514 Spring Mill Road, Villanova

Historical Commission

Preliminary Consultant Review

914 Black Rock Road, Gladwyne

East Elevation

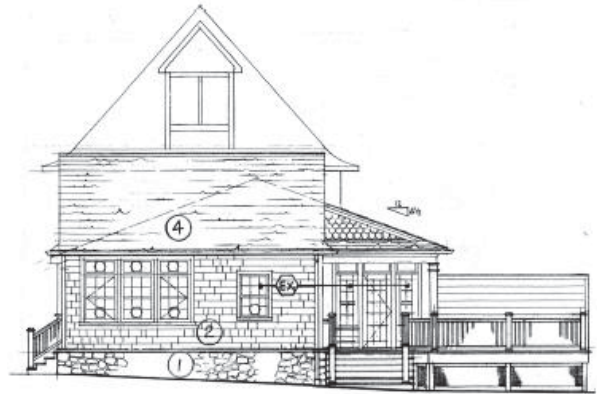
The existing residence has "grills-between-glass" replacement windows, installed prior to historic designation and not considered appropriate under the HC guidelines.

The applicant proposes to use the same type of windows in the proposed addition.

Left Side Elevation

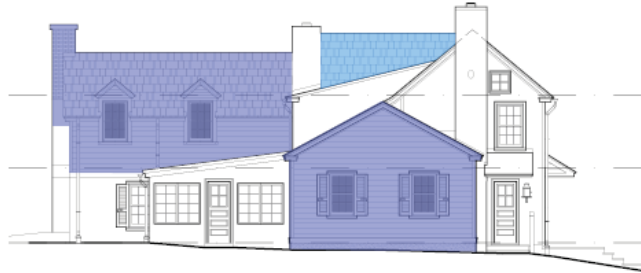
- The submitted drawings graphically depict where work is occurring, but annotation and dimensions should be added to the drawings to confirm what is new and what is existing, and a few additional details should be provided and specified.

- Questions / details to be clarified are as follows:
 - What is the specification for the metal roof?
 - What is the specification for the brick chimney that will extend the existing brick chimney? And the chimney cap?

- Are the new Timberlane shutters only at the new volumes or are any of the existing shutters being replaced?
- Is the existing roof of the main gable being replaced, or only the rear-right slope being patched when the shed dormer is removed to make way for the new cross gable?
- What are the specifications for the gutters and downspouts? (All or just new roof areas?)
- What is the cornice detail and how will it intersect the existing cornice?
- Will the new window and door trim match the details at the existing house or be different?
- The materials list notes mahogany selection for wood windows but the further material cut sheets notes pine – which is correct? (Mahogany is recommended for exterior.)

Given the appropriate submissions to clarify items noted above, we recommend approval of this application, in accordance with Standards 9 and 10.
